DISTRIBUTION**Process Change Notice****ZCAT series Change of production location and ZCAT-DT type Change of adhesive tape**

Clamp Filters (Ferrite Core with Case)

ZCAT series

Transfer of production location

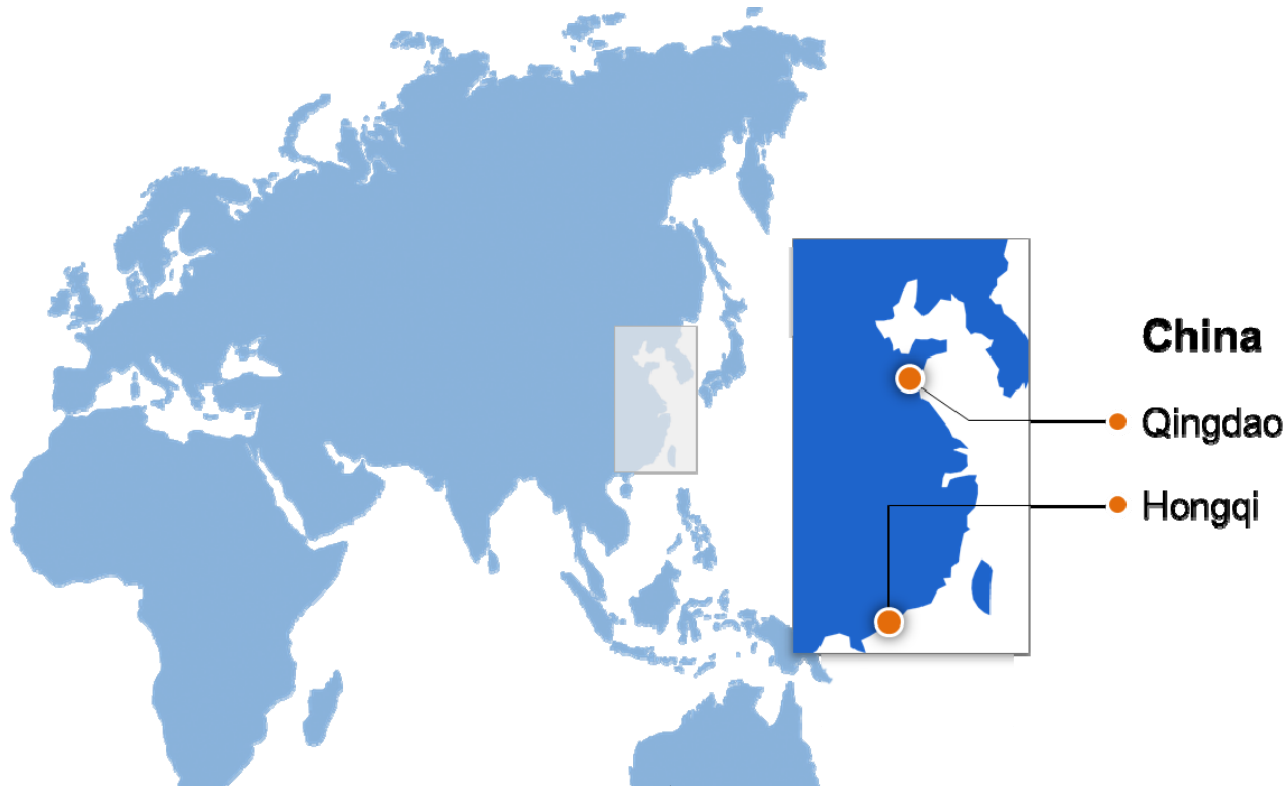
TDK would like to transfer production location of clamp filters ZCAT series from EPCOS Zhuhai (China) to Qingdao TDK Electronics (China) for optimization of production locations in TDK group.

In ZCAT-DT type, which is ZCAT with adhesive tape, current adhesive tape has been discontinued in tape-supplier.

Then, TDK would like to change the current adhesive tape to the compatible one.

- All items in clamp filters ZCAT series

- Only ZCAT-DT type (ZCAT with adhesive tape) in ZCAT series
